NESPOR 1ST ADDITION TO SEDGWICK COUNTY, KANSAS LOT 1 BLOCK 1

RE: S/D 99-17 -- One-Step Final Plat of NESPOR FIRST ADDITION

CASE NUMBER: S/D 99-17 - NESPER 1ST ADDITION

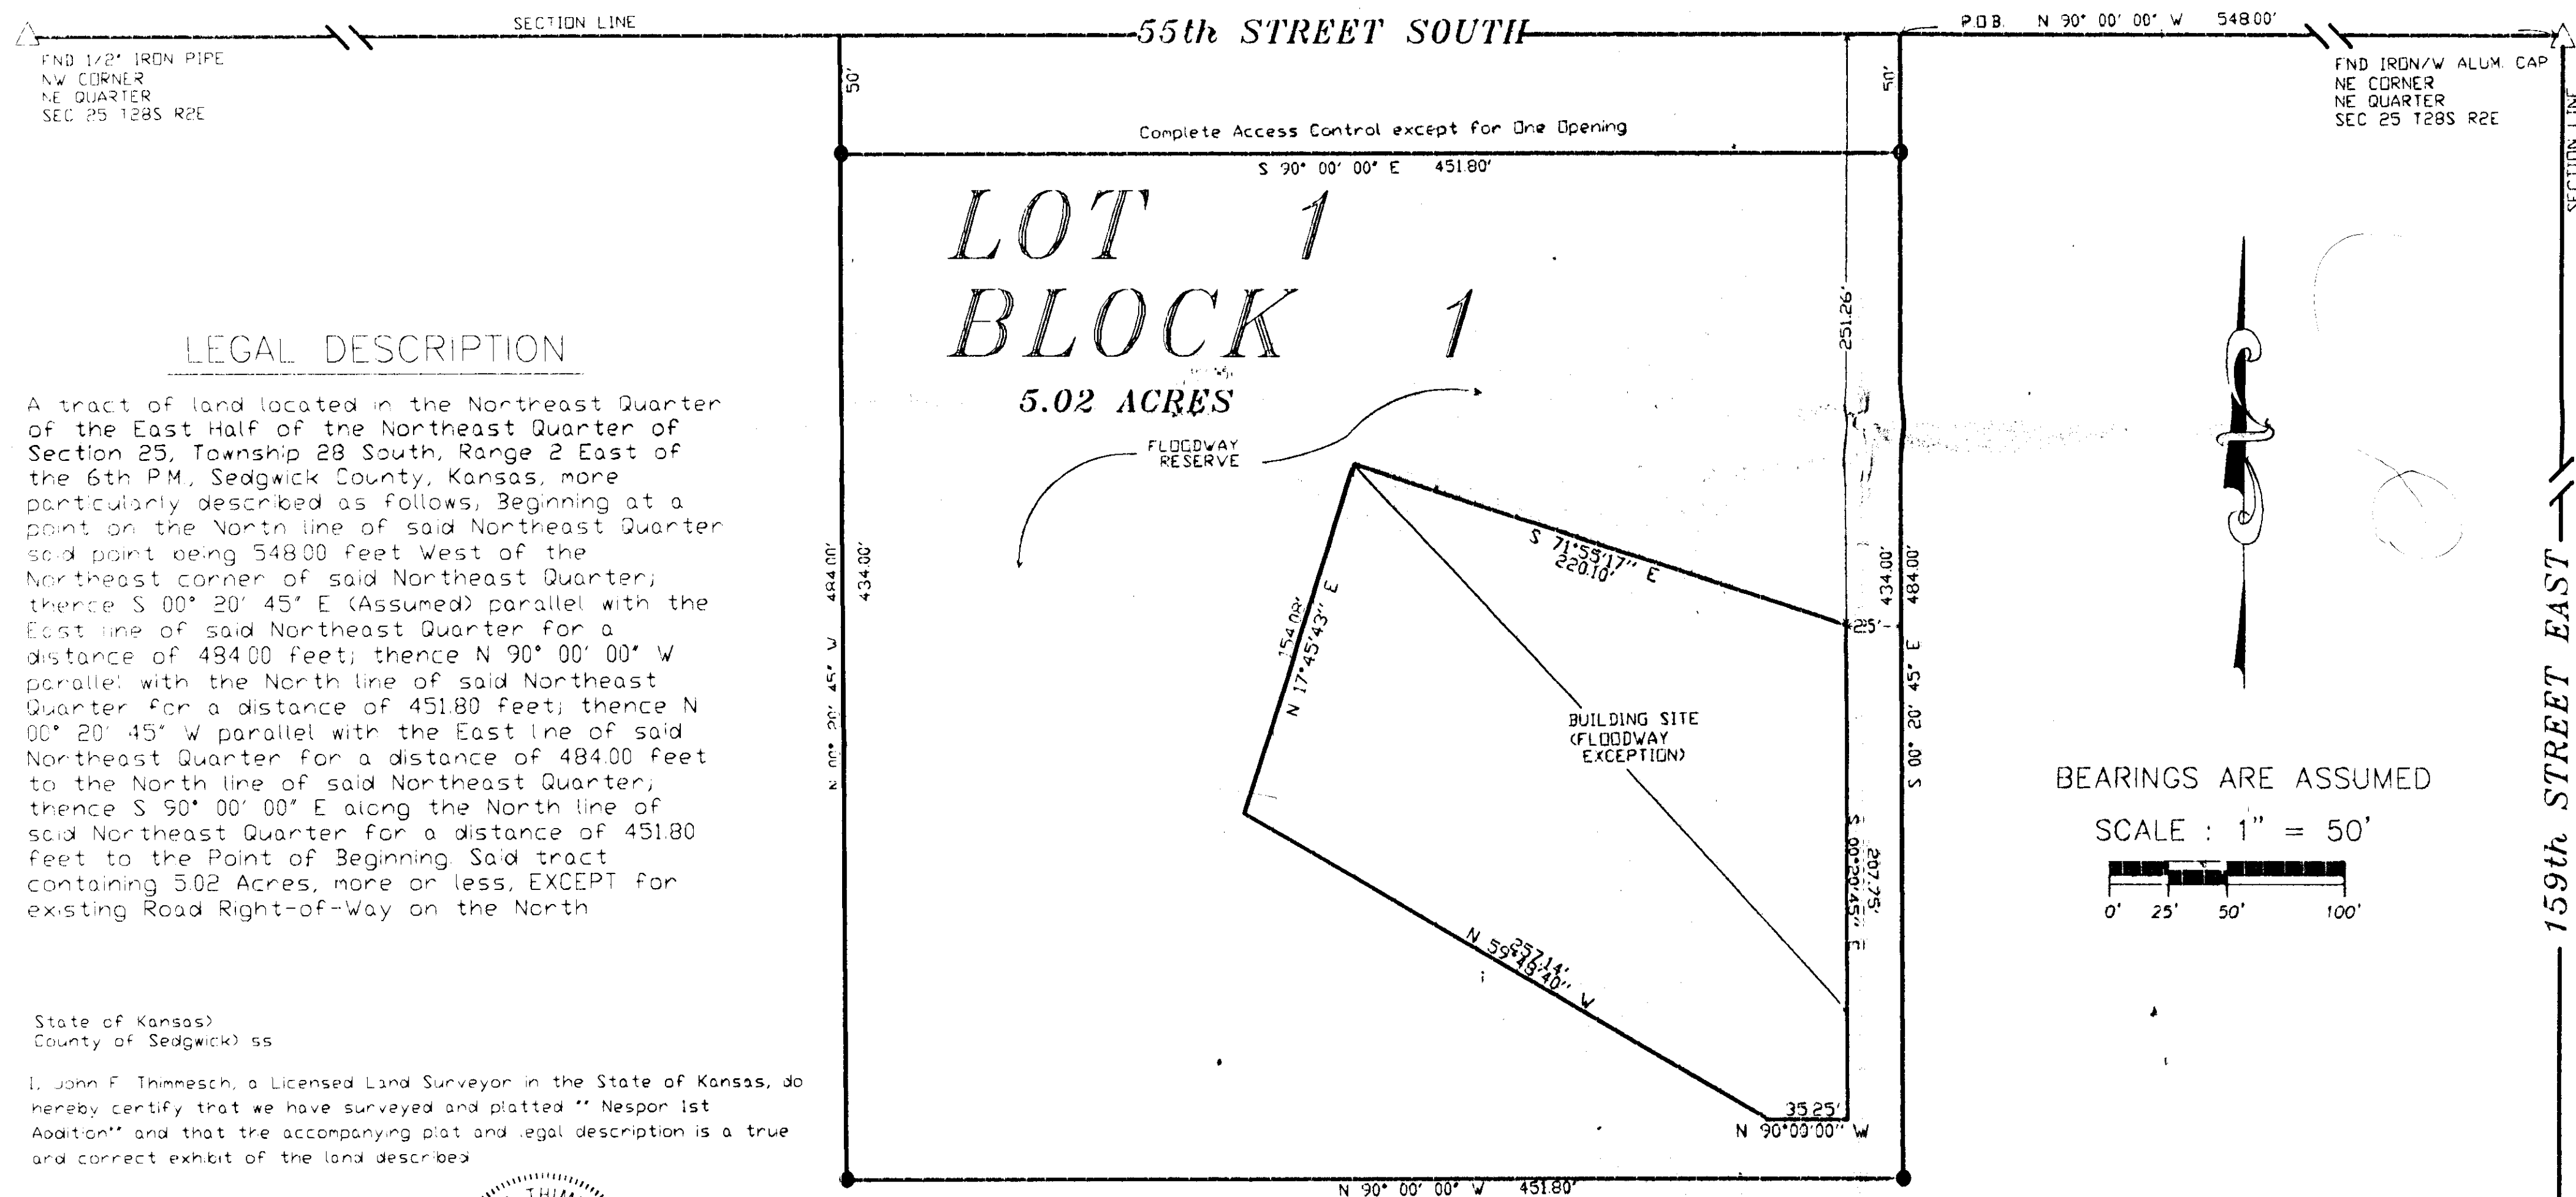
- A. Since neither municipal water nor sanitary sewer is available to serve this property, the applicant shall contact the Environmental Health Division of the Health Department to find out what tests may be necessary and what standards are to be met for approval of on-site sewerage facilities and water wells. A memorandum shall be obtained specifying approval.

County Health needs to comment on the buildable area of the site as the floodplain and pond may present constraints for construction of an on-lot sewage system. County Health has approved the location of the sewage lagoon contingent upon the applicant receiving a letter of map revision from FEMA. In the alternative, the location of the lagoon will need to be within the western portion of the "proposed building location" as denoted on the preliminary plat. The applicant shall place a note on the face of the plat clarifying lagoon placement.

- C. County Engineering needs to comment on the status of the applicant's drainage plan. The drainage plan is approved. A floodway reserve needs to be platted along with minimum building pad elevations. The creation of the floodway reserves and the standard floodway language needs to be included in the plat's text.

- D. The final plat tracing shall denote complete access control except for one opening along 55th St. South. Access controls shall be referenced in the plat's text.

- E. The first line of the legal description needs to be revised to reference the northeast "quarter".

- F. The County Commissioners signature block needs to be revised.
- G. The applicant is reminded that a platting binder is required with the final plat. Approval of this plat will be subject to submittal of this binder and any relevant conditions found by such a review.

- H. The Planning Commissioner signature block needs to be revised to include, "Dated this ____ day of _____, 1999."
- I. The notary signature block needs to be revised to eliminated reference to "Waco Township"

- J. The signature blocks need to be revised to reference "1999".
- K. The applicant shall install or guarantee the installation of all utilities and facilities which are applicable and described in Article 8 of the MAPC Subdivision Regulations. (Water service and fire hydrants required by Article 8 for fire protection shall be as per the direction and approval of the Chief of the Fire Department.)
